**RE: NW Bicester: Hawkwell Village: Outline application (with all matters reserved except for Access) for a mixed use development of up to 3,100 dwellings, local centre, employment areas, schools, green infrastructure and associated infrastructure (reference 21/04275/OUT)**

1. This document is prepared on behalf of Bucknell Parish Council in response to the further submissions dated the 24<sup>th</sup> March 2023 made by David Lock and Associates on the behalf of the developer Applicants (hereafter referred to as “The Applicants” or the “developer”) and the various new material recently produced in support of the application which has been submitted by the Applicants throughout February, March and April 2023, with the latest technical documents in support being served as late as the 18<sup>th</sup> and 19<sup>th</sup> April 2023.

**Figure 5: The additional coalescence of land of the Hallam Application compared to that agreed as part of the adopted Local Plan (highlighted in Purple below):**

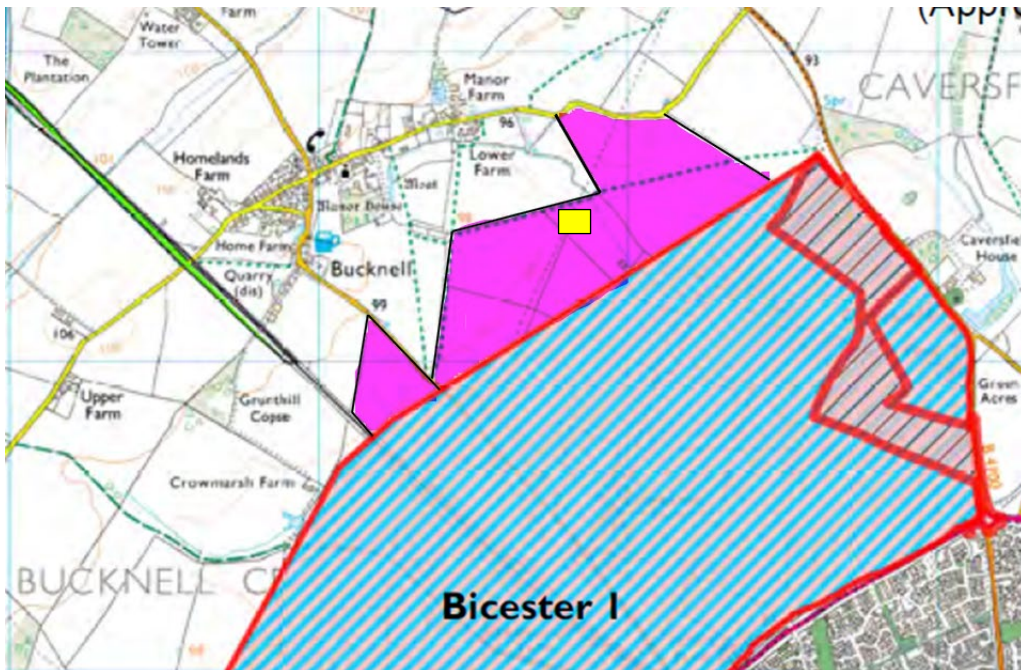
140. In the above map, as well as the purple representing further land taken for development by this Application, over what was set out in the Adopted Local Plan, the purple area also highlights land that is in the Parish of Bucknell and as such the building policies and regulations of the National planning regulations, relating to proposed large scale developments in small rural villages apply, as do the policies of Oxfordshire County Council and CDC against such development. Additionally, the yellow square shows the position of the nearest proposed dwellings to Bucknell village (for comparison below), with a large number of houses being proposed under these plans to be actually built within the boundaries of Bucknell.

141. As well as increasingly the land covered in the Local Plan for the Hawkwell part of the general Bicester 1 area of development by around 33%, by increasing the land they are proposing to use, by adding large tracts of land within the parish of Bucknell, the developers are also moving all main points of the development site significantly closer to and into the village of Bucknell itself, meaning that in reality the plans, if approved, would merge the town/Garden city of Bicester with the village of Bucknell.

**Figure 6 – the nearest housing according to the newly released figures from the Applicants showing 900m from the cross-roads in Bucknell**

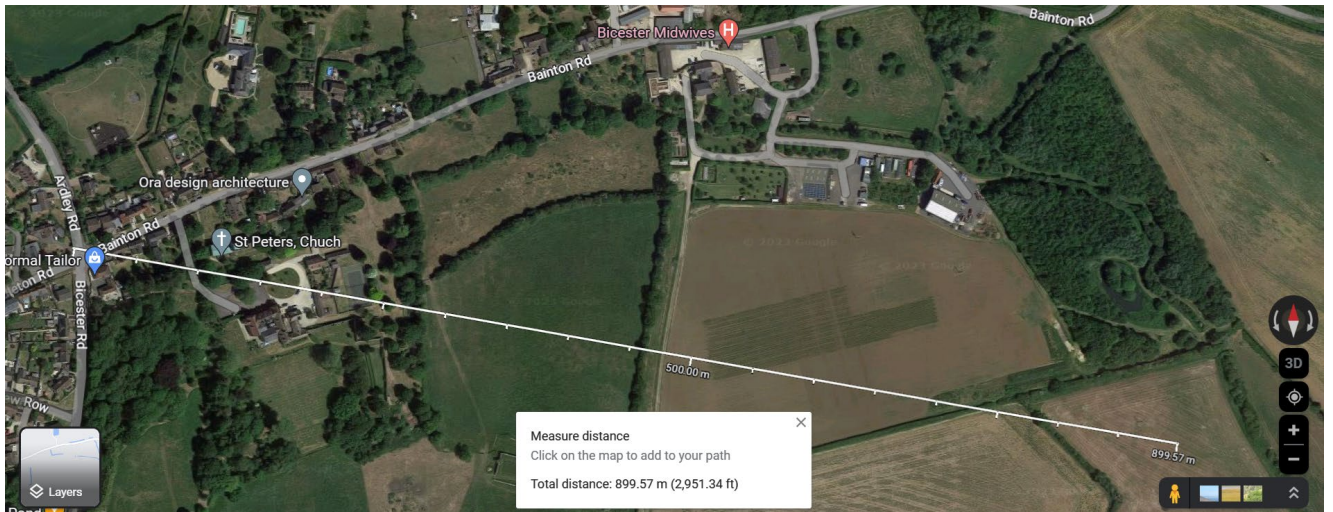
142. To demonstrate what the proposed changes in the plan of the Applicant mean in comparison to that allowed under the Local Plan, we have set out below a series of maps based on the figure now provided by the developers as to where they claim the nearest property would be, although an examination of the actual fields which have been designated by the developers for the building of dwellings, shows in fact that the nearest houses would in any event be considerably closer than the claimed figure of 900m from the cross-roads (it not clear how the Applicants have calculated their figures).

**Figure 7 : 200 meters to the nearest building (work spaces) within Bucknell:**

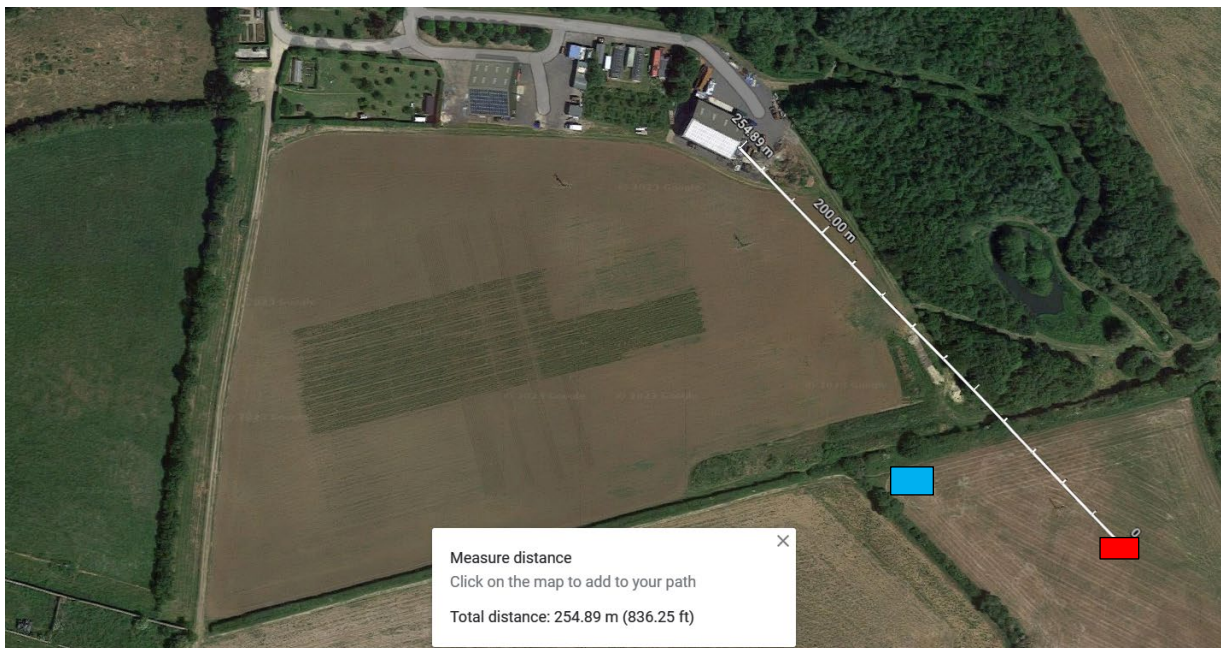
143. However, the above images demonstrates how the figures of the Applicant are clearly not accurate. Although 900m from the cross-roads, on an arc takes the nearest house to the point of the Red Square (above), the Applicants are proposing to build dwellings up to the boundary of that same field, which would in fact mean that the nearest dwelling and the infrastructure such as street lights would be up to the point of the Blue Square

Figure: Showing the same three positions as above on the Adopted Local Plan (CDC's NW Bicester doc: NW\_Bicester\_Masterplan\_BIMP6\_01\_02\_03 (1)):

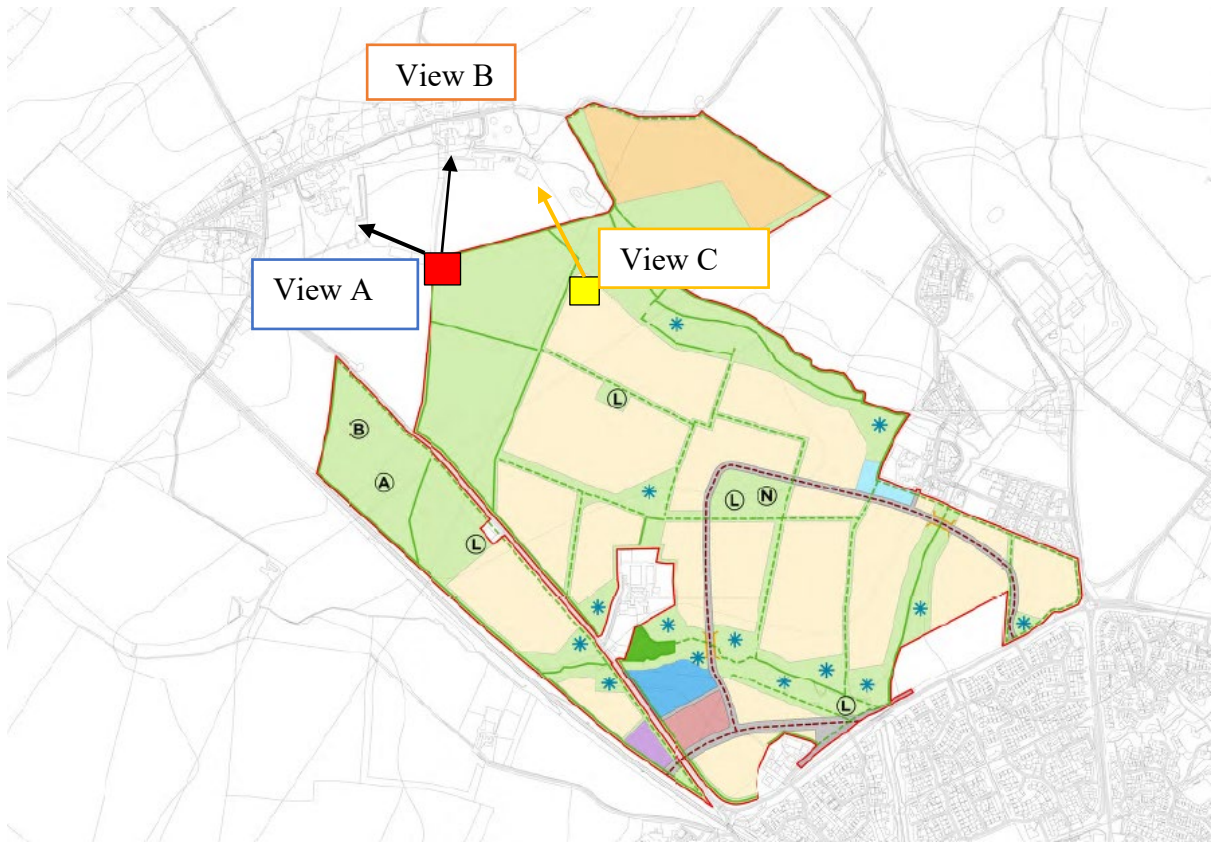
146. As a result of the Applicant's plans and attempts to extend the development, there will be across the key points of the development a 50% decrease in the size of the buffer between the development and Bucknell, leading Bucknell as an independent entity being coalesced and merged into Bicester.
